# Wisconsin Department of Transportation

**Proposal #01: 1010-10-82, WISC 2024324**  
**Madison – Portage**  
**Wisconsin River Bridges**  
**IH 39**  
**Columbia County**

This is Addendum No. 03, which provides for the following:

**ADDENDUM NO. 03**

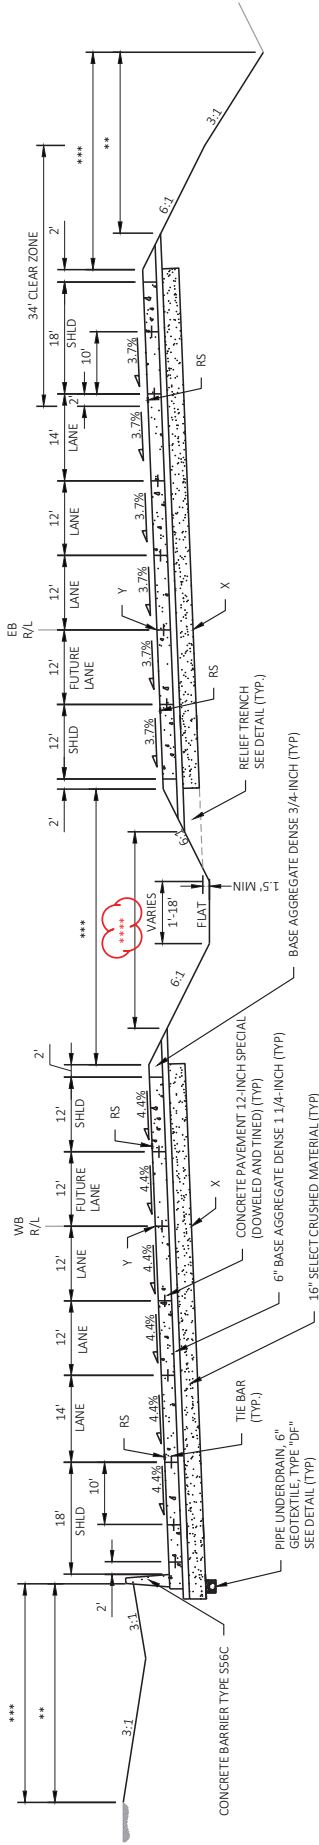
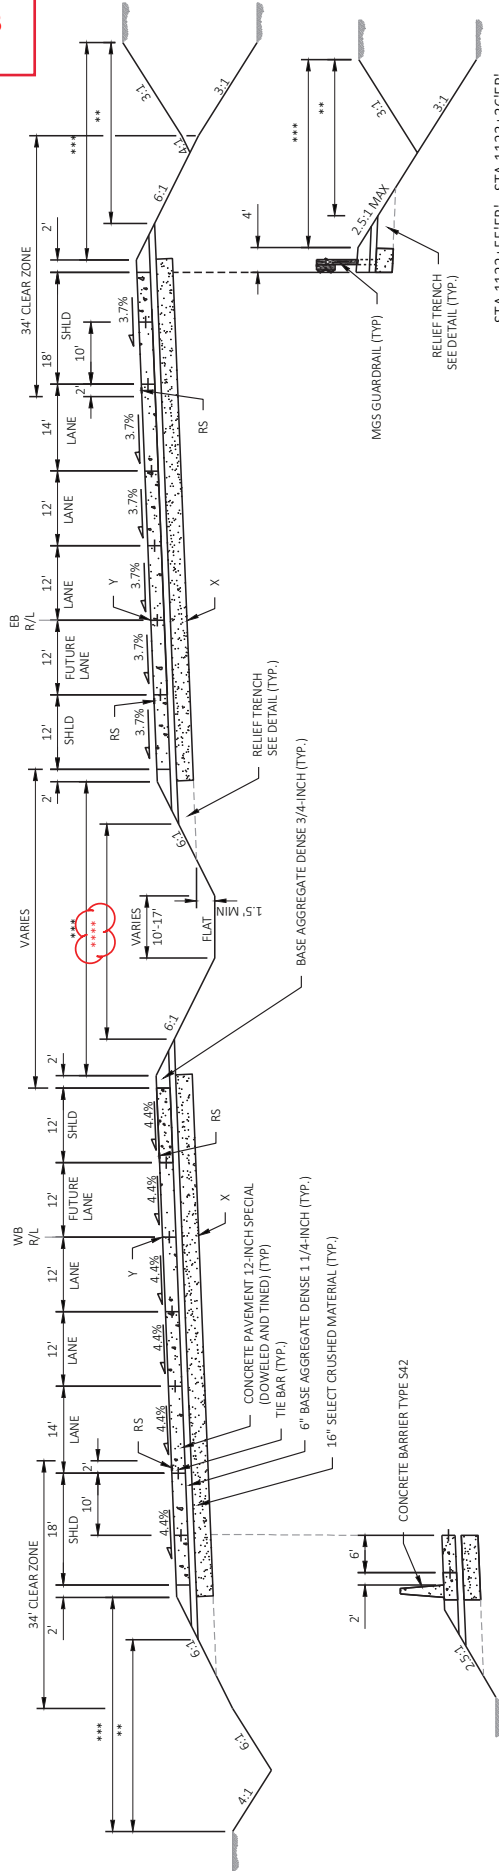
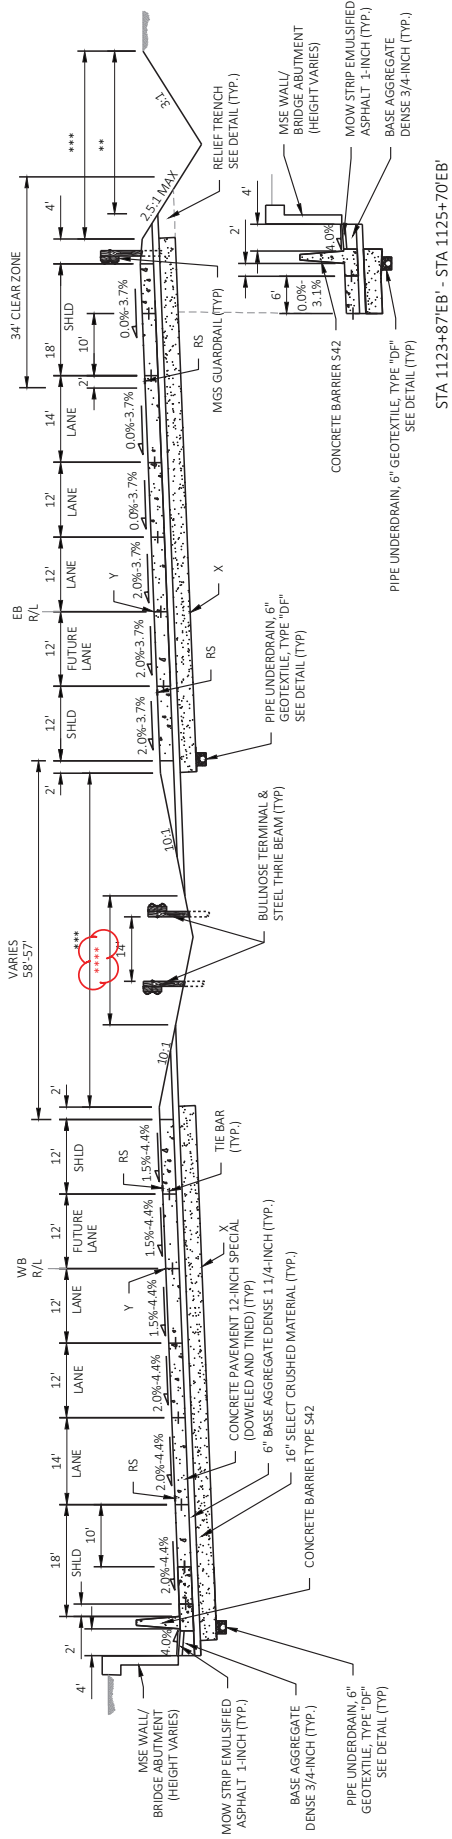
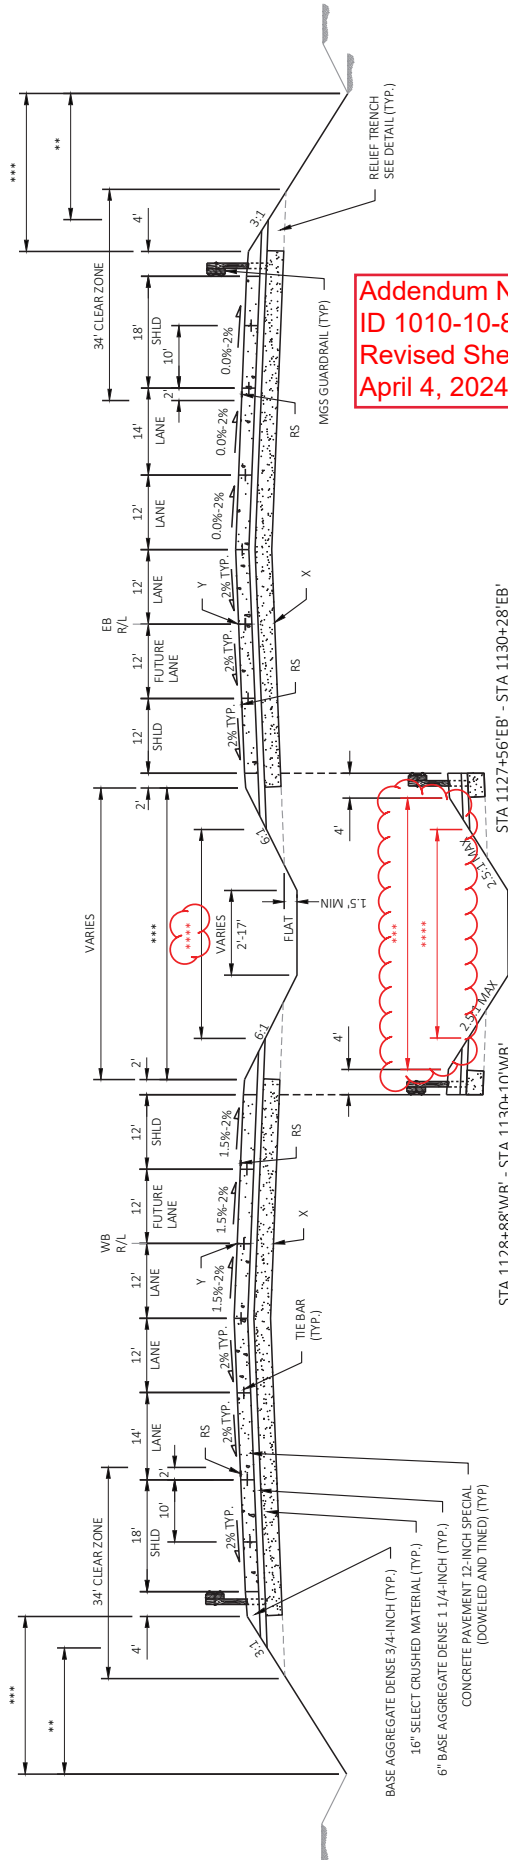
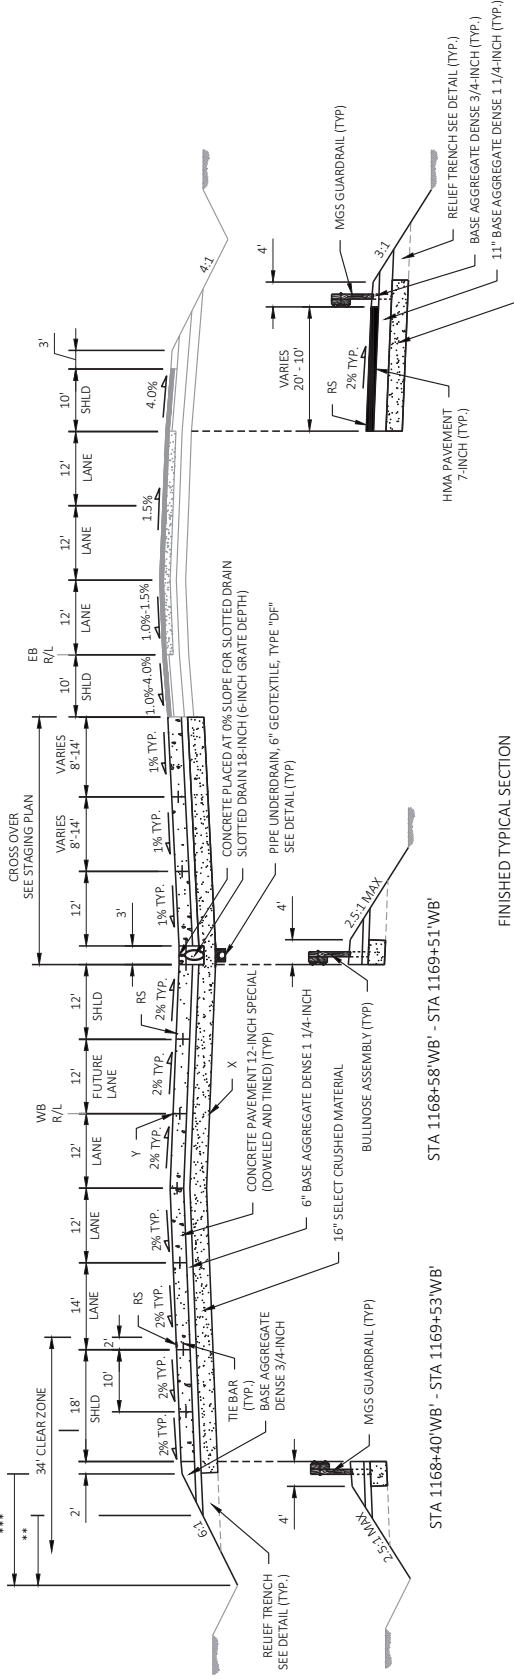
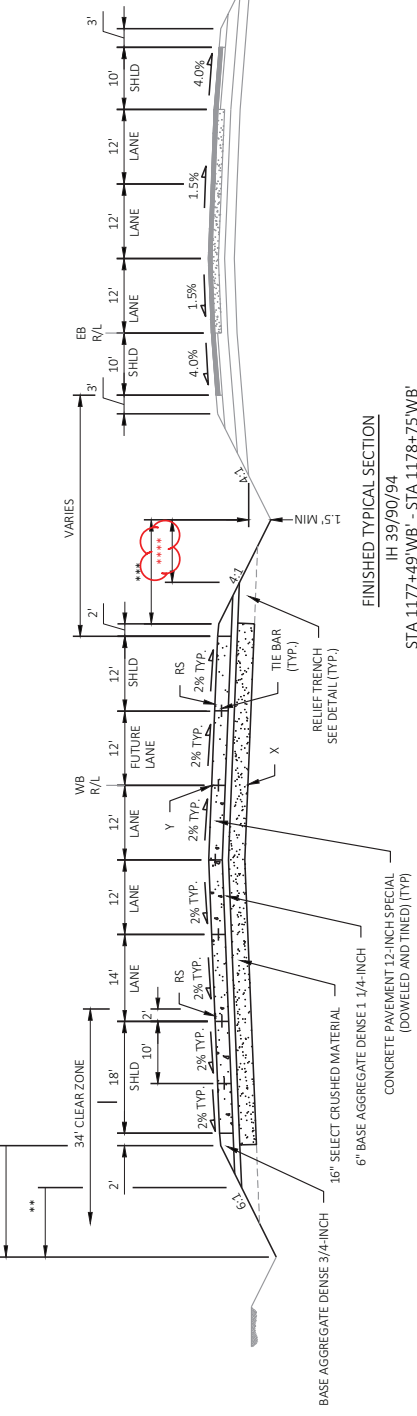
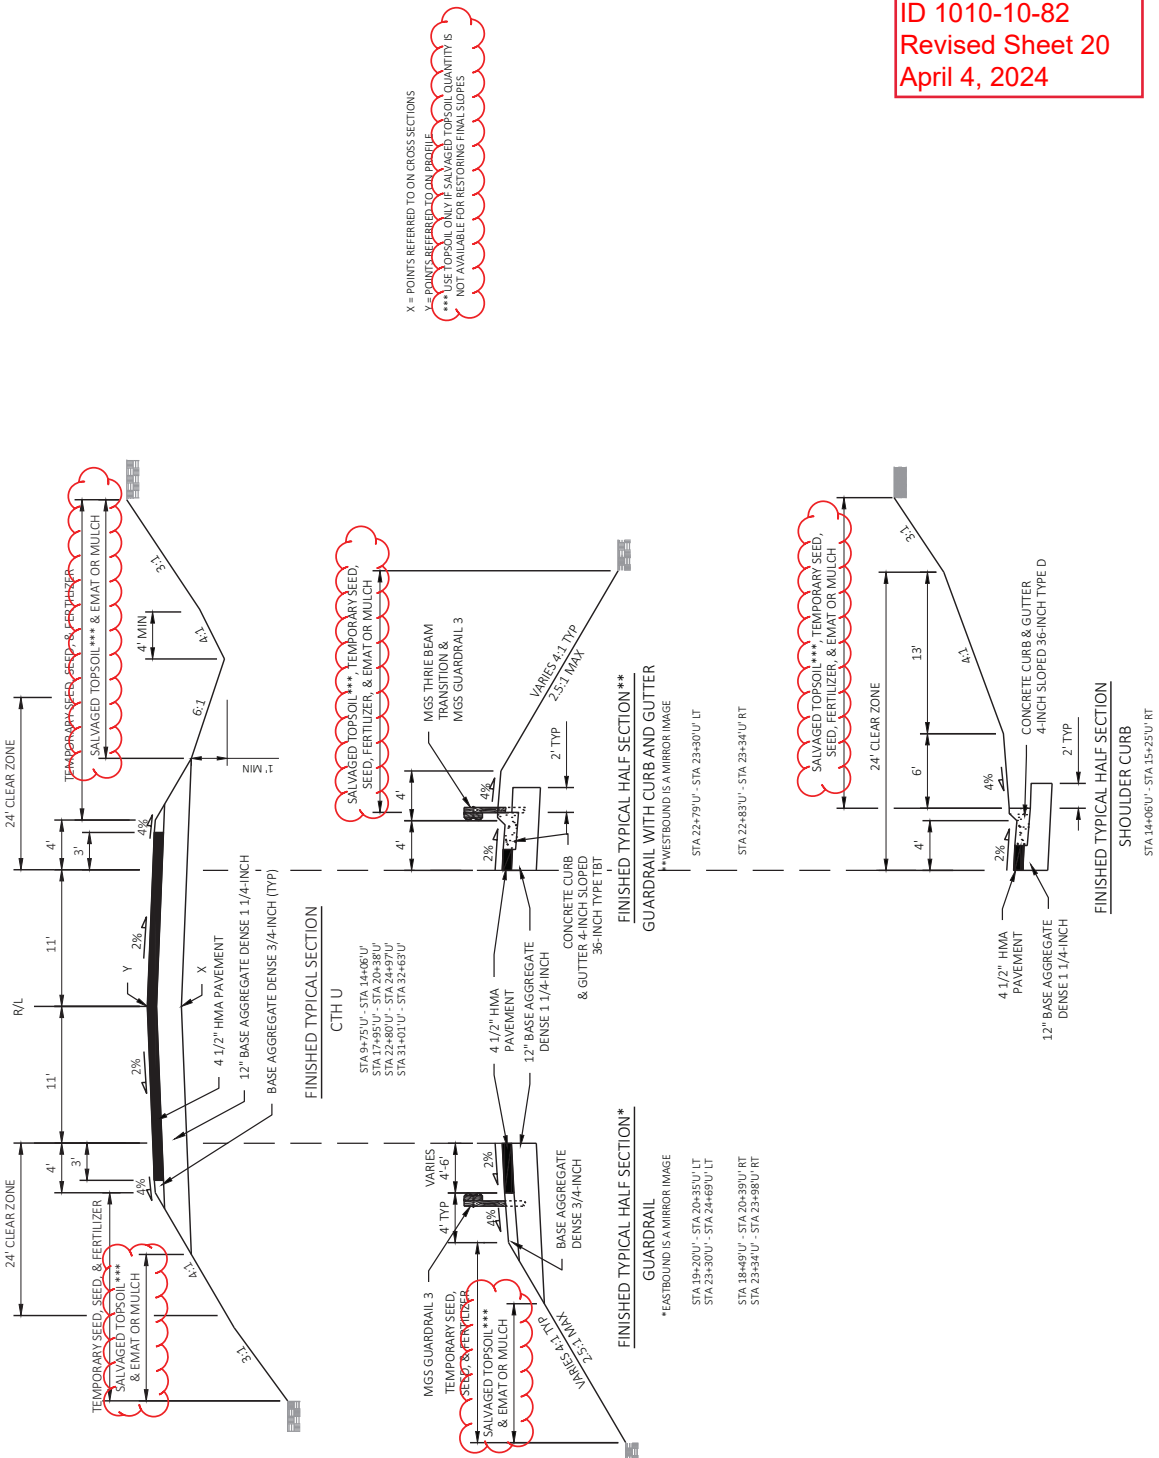
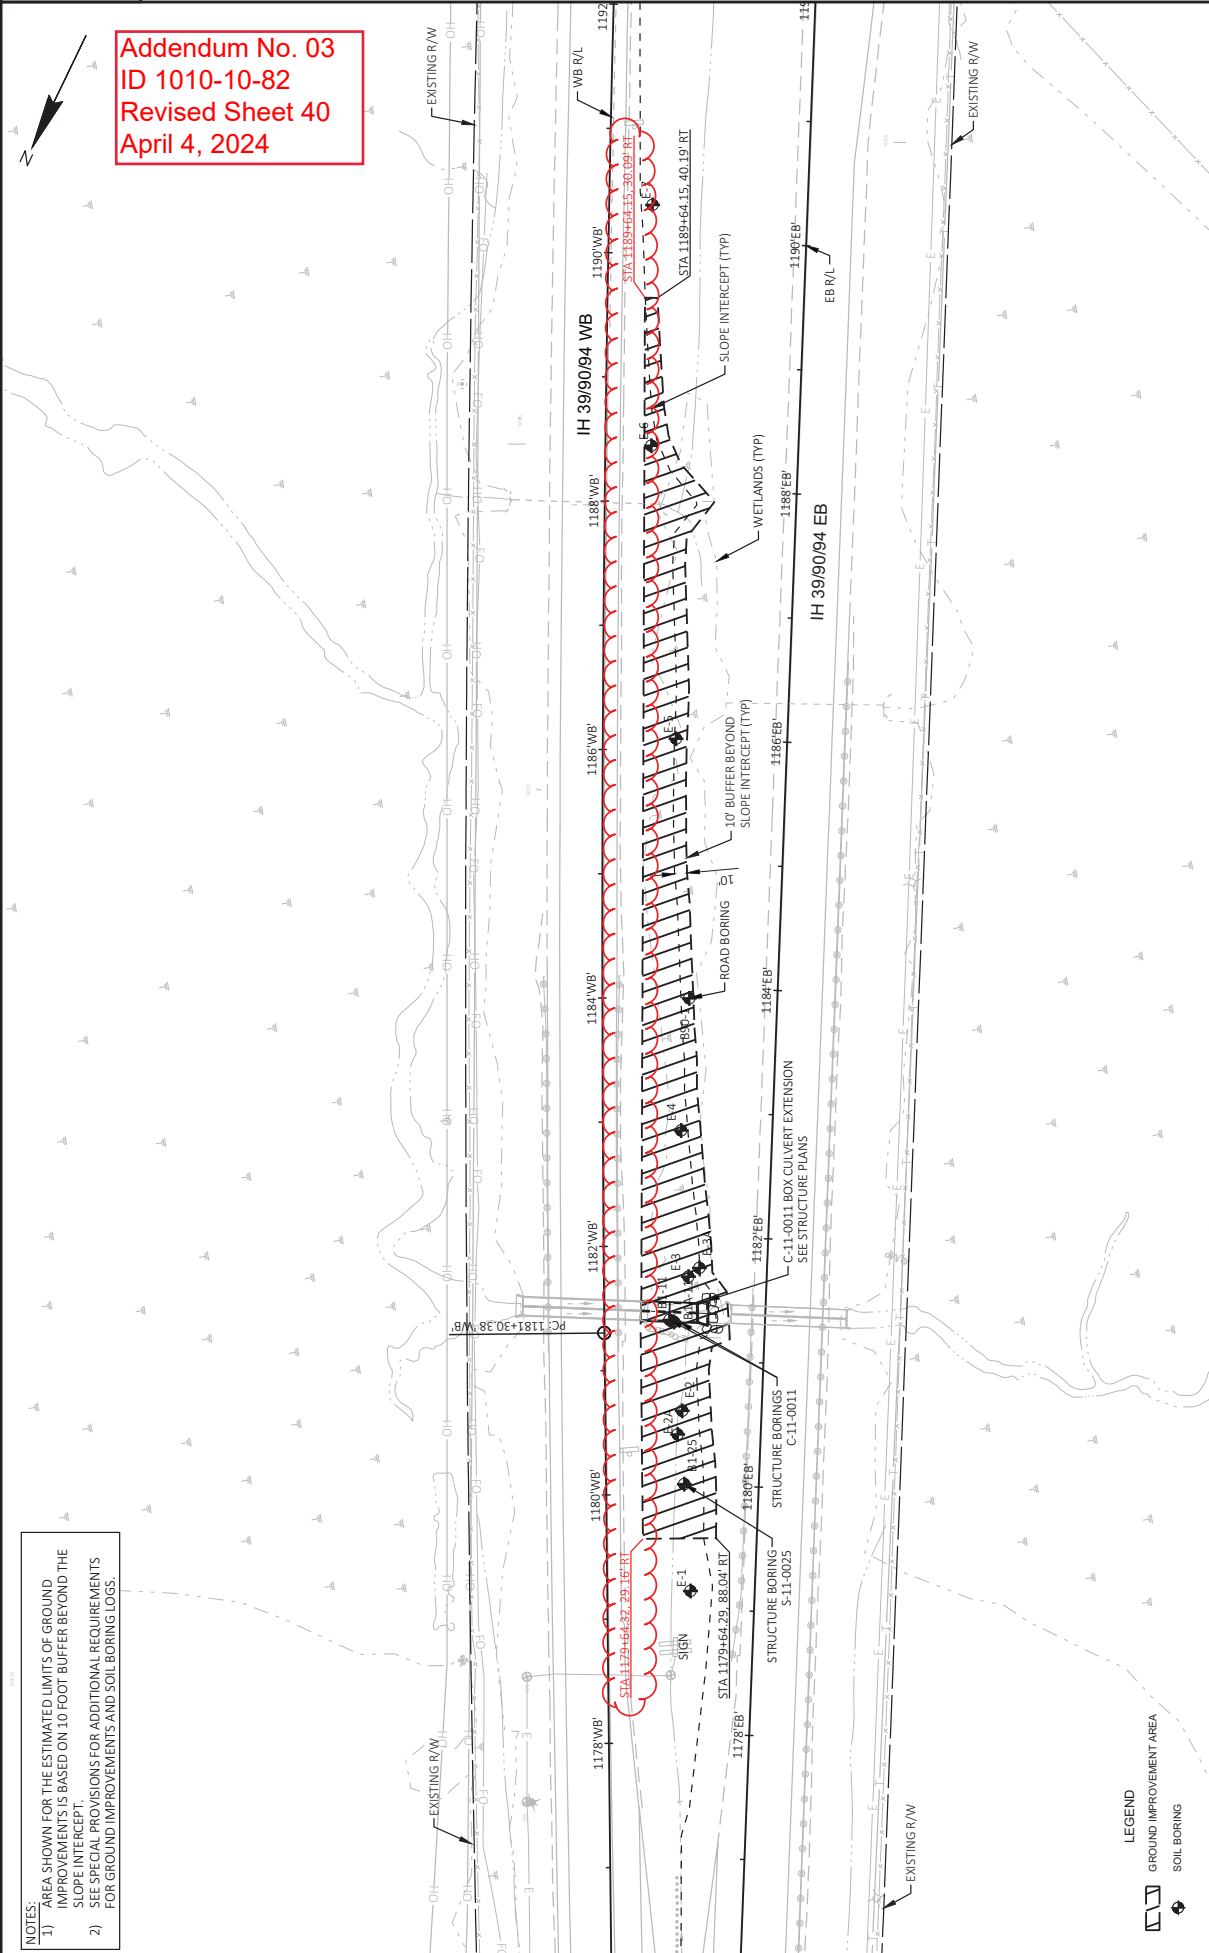
<b>Revised Plan Sheets</b>	
<b>Plan Sheet</b>	<b>Plan Sheet Title (brief description of changes to sheet)</b>
11 to 23	Finished Typical Sections – Added/ revised notes to clarify where salvaged topsoil is expected to be used and where topsoil is expected to be used.
40 & 41	Construction Details – Median Ground Improvement – Updated the limits of ground improvement required by removing existing slope area on sheet 40 and revised a note on sheet 41.
416	Miscellaneous Quantities – Updated Mulching and Fertilizer Type B quantities to be included when Temporary Seed is used.
428	Miscellaneous Quantities – Revised the quantity of Ground Improvement Rigid Inclusion System based on revisions made to plan sheet 40.
676	B-11-183 Structure Plan – Minor revisions to structure quantities.
734 to 738	B-11-183 Structure Plan – Additional notes included.
778	B-11-184 Structure Plan – Minor revisions to structure quantities.

X = POINTS REFERRED TO ON CROSS SECTIONS  
 Y = POINTS REFERRED TO ON PROFILE  
 \*\*\* USE TOPSOIL ONLY IF SALVAGED TOPSOIL QUANTITY IS NOT AVAILABLE FOR RESTORING FINAL SLOPES

X = POINTS REFERRED TO ON CROSS SECTIONS  
 Y = POINTS REFERRED TO ON PROFILE  
 \* USE TOPSOIL ONLY IF SALVAGED TOPSOIL QUANTITY IS NOT AVAILABLE FOR RESTORING FINAL SLOPES

X = POINTS REFERRED TO ON CROSS SECTIONS  
 \* POINTS REFERRED TO ON CROSS SECTIONS  
 \* USE TOPSOIL ONLY IF SALVAGED TOPSOIL QUANTITIES NOT AVAILABLE FOR RESTORING FINAL SLOPES

Addendum No. 03  
ID 1010-10-82  
Revised Sheet 40  
April 4, 2024

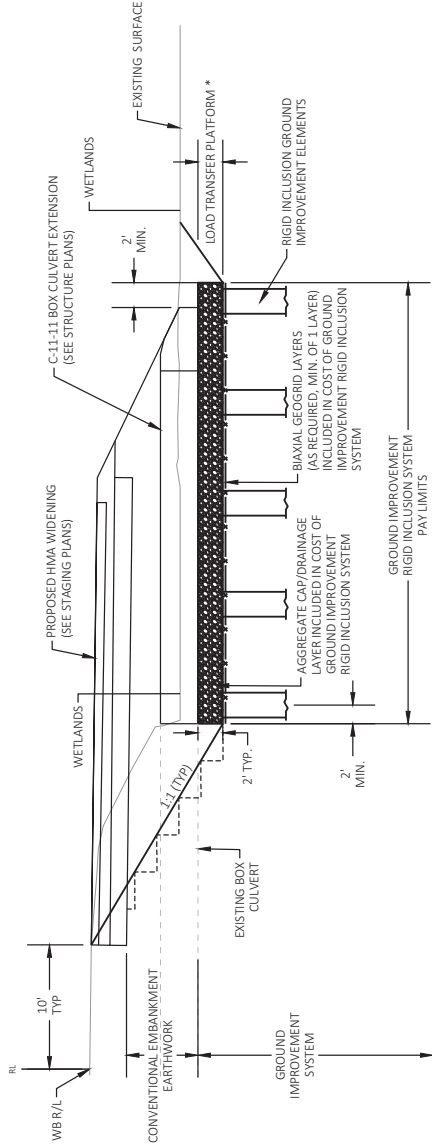
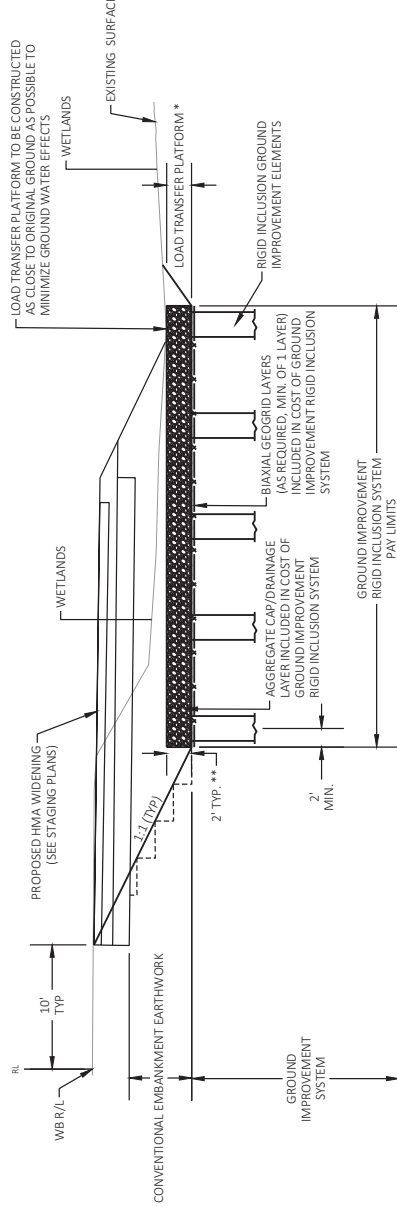
NOTES:  
\* MAY INCLUDE COMBINATION OF GEOSYNTHETICS AND AGGREGATE  
\*\* AFTER TEMPORARY WIDENING IS NO LONGER REQUIRED, REMOVE SUFFICIENT THICKNESS OF THE LOAD TRANSFER PLATFORM, IF REQUIRED, SO A MINIMUM OF 6" OF TOPSOIL CAN BE PLACED FOR REESTABLISHING MEDIAN VEGETATION AND DRAINAGE. REMOVAL, IF REQUIRED, WOULD BE PAID FOR AS COMMON EXCAVATION.
